TYPICAL BWR GETAB APPLICATION

Plant Information Request1. QUESTION:

Figure 3-1 Histogram of Relative Bundle Power
Used In GETAB Statistical Analysis

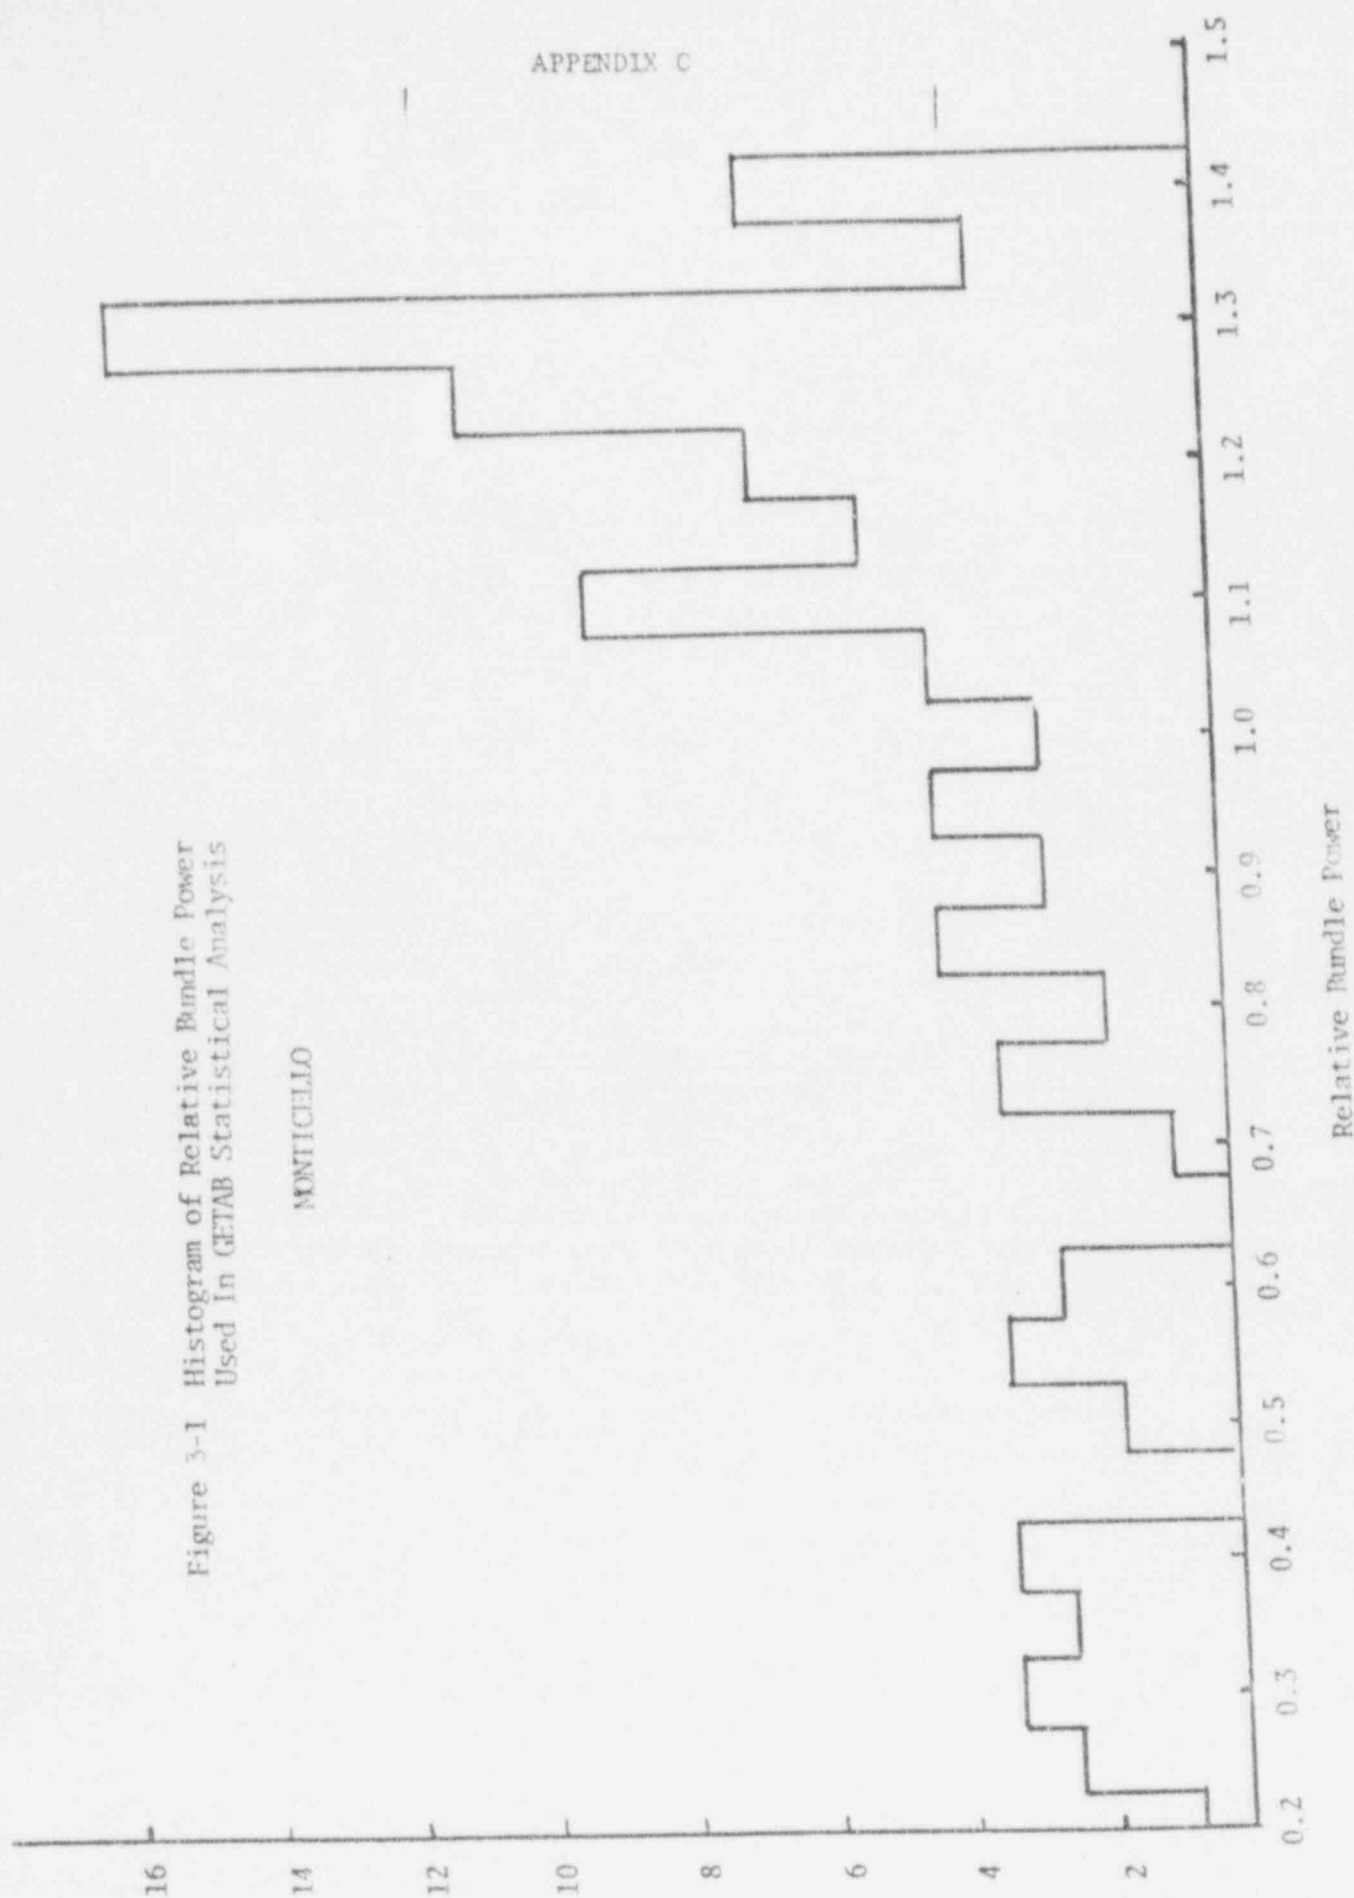
3. QUESTION:

Identify the relative bundle to bundle power distribution (by histogram method) that is employed in the application of the GETAB statistical analysis to Monticello.

RESPONSE:

The histogram of relative bundle power used in GETAB statistical analysis for Monticello is shown in Figure 3-1. This histogram was generated by arranging the control rod pattern such that the maximum number of fuel assemblies were placed at positions of minimum MCPR as described further in NEDO-10958 Appendix IV.
